Access Compliance Report

Public Rights-of-Way

(Curb Ramps)

Intersection ID: 13432	Main Street: E_8TH_ST	Cross Street: LOUISE_AV	Location: SE
ADA ID: 8E9F51072676	Ramp Type: BlendTrans2	Initial Pass/Fail: Pass	Overall Compliance: No
Severity Score: 30			
Codes/Mitigation Info/Possible Solution		Field Measurements/Component Compliance

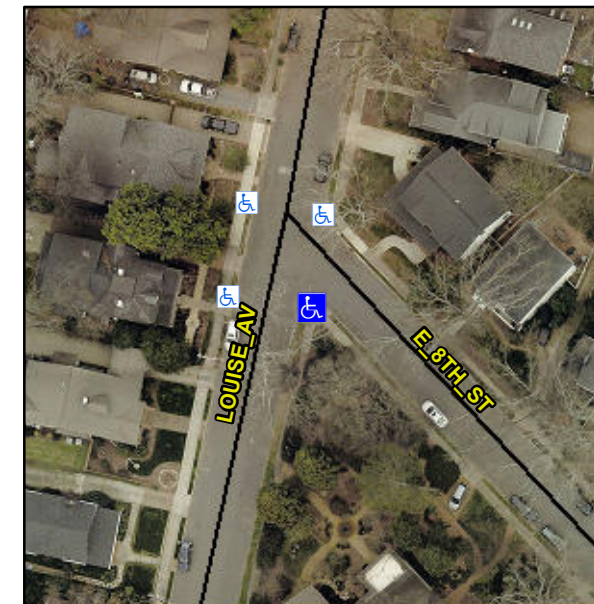
**Install Detectable Warning System.
Remove & Replace Gutter.**

GTR GAP 2.0

R305, R302.7, R302.7.2, R304.5.4
